Re: High Banks on The Severn - Variance Application  
641 Lakeland Rd S, Severna Park Maryland 21146 ("Property")  
Tax Map 31, Block 3, Parcel 246 (Lot 5)  
Explanation Letter

PROJECT NOTIFICATION APPLICATION

## OFFICE OF PLANNING AND ZONING

ZOVING: R-2 / LDM  
UNDEL COUNTY, MARY  
SHEET: 2 OF 2

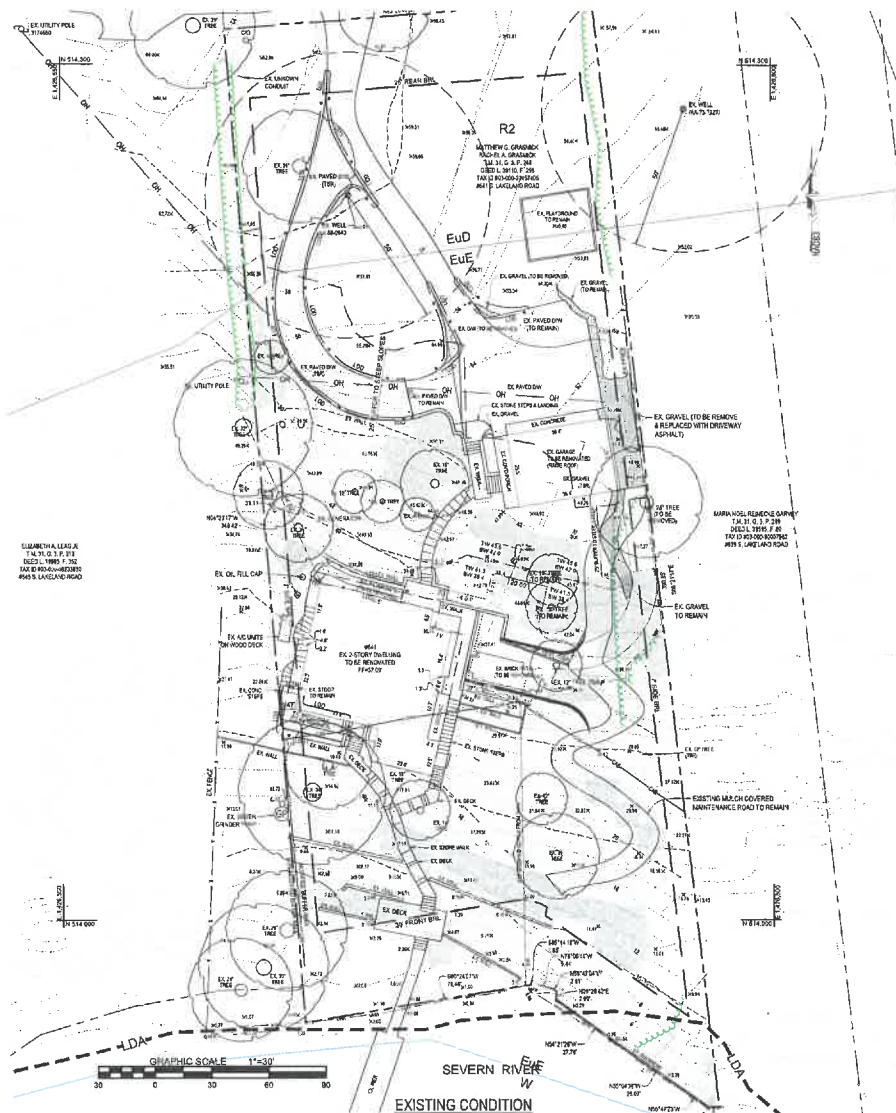
The existing critical area lot coverage of the site is noted as 11,068 square feet (and also 10,877sqft on sheet 2).

The site plan should be revised to clarify the lot coverage summaries, as some of the figures do not correspond.
